# Review for the 2016 Update of the Paducah Gaseous Diffusion Plant Sitewide Groundwater Flow Model

February, 2018

Figure A1: Water level differences between two periods vs distances to nearest pumping well. The difference in each well was defined as water level in SP1 minus water level in SP2

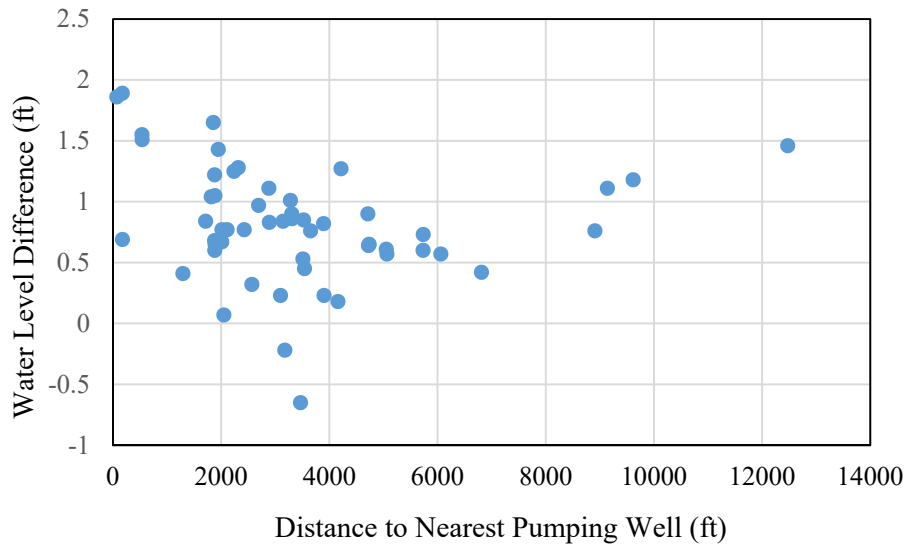
A major difference in model configuration between the two stress periods was that SP2 included two pump-and-treat sites with a combined pumping rate of 411 gpm. Groundwater pumping at the sites can lower water levels in some monitoring wells. However, comparison of the water level differences between the two periods versus distance to nearest pumping wells showed the water level differences had little correlation to pumping (Figure A1). The correlation coefficient between water level differences and distances to nearest pumping well was -0.1, suggesting pumping was not the main reason for the lower water levels in SP2 than in SP1. Particularly, four monitoring wells (MW137, MW147, MW199, and MW201), which were located more than 1.5 miles (ranging from 8,910 – 12,475 ft.) north of the pumping sites, had water levels more than 0.7 ft. higher (0.76-1.46 ft.) in SP1 than in SP2 (Table A1). The pumping at the two pump-and-treat sites should have little impacts to water levels in these wells given their distances to the pumping sites.

Figure A2: Comparison between a) observed hydraulic gradient and b) model calculated gradient. The data used in this figure were from Table 6.8 in the 2016 update report

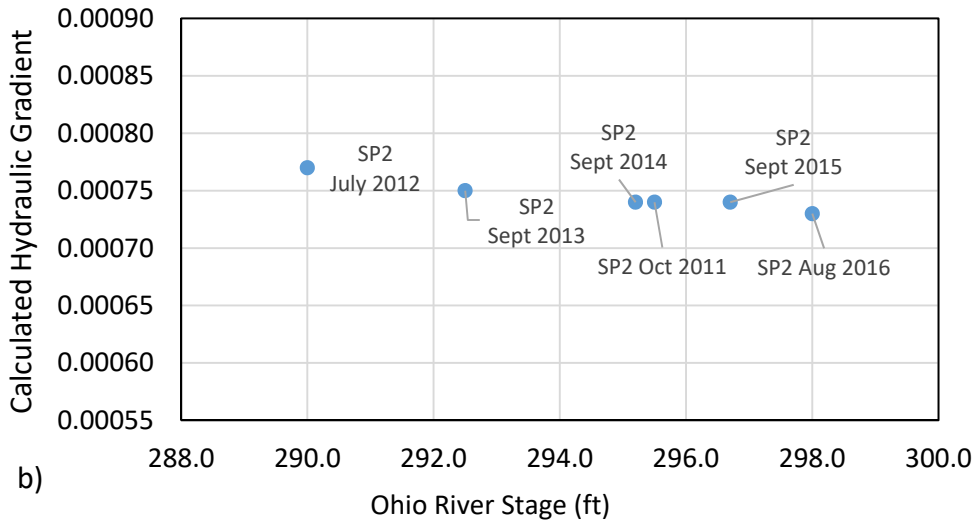
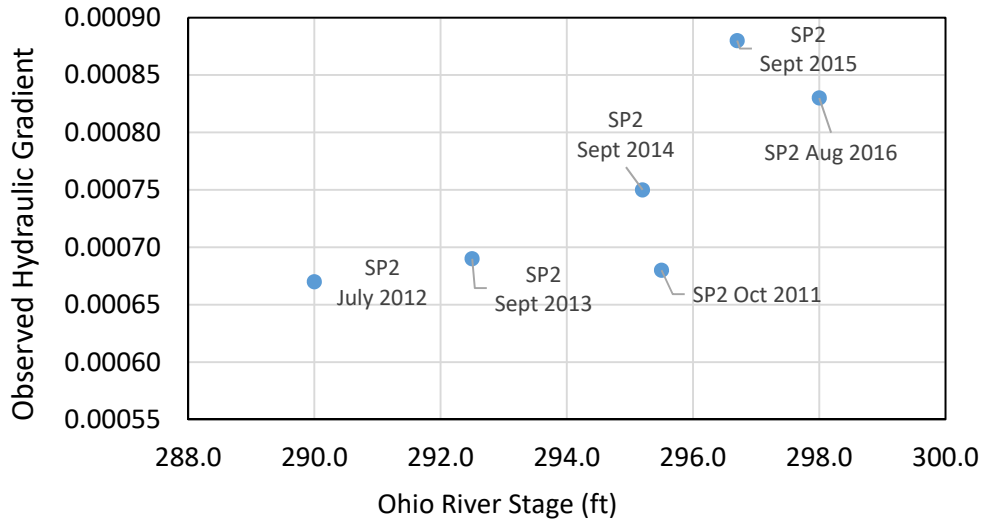
The evaluation of hydraulic gradient was only done to one pair of monitoring wells. Even with this one pair, the model calculated gradients were not consistent with the measured gradients. Although the model calculated gradients were in the same order of magnitude with the observed values, the impacts of changes in the Ohio River stage on the gradient were not reflected correctly. Figure A2a showed that hydraulic gradient generally increased with increasing Ohio River stage when the stage was in the range of 290 – 300 ft. But the model calculated gradient decreased with increasing Ohio River stage (Figure A2b). Also, the magnitude of hydraulic gradient response to Ohio River stage was much less than observed. For the six periods included in the figure, the range of observed hydraulic gradient was 0.00021 whereas the range of simulated hydraulic gradient was only 0.00004.
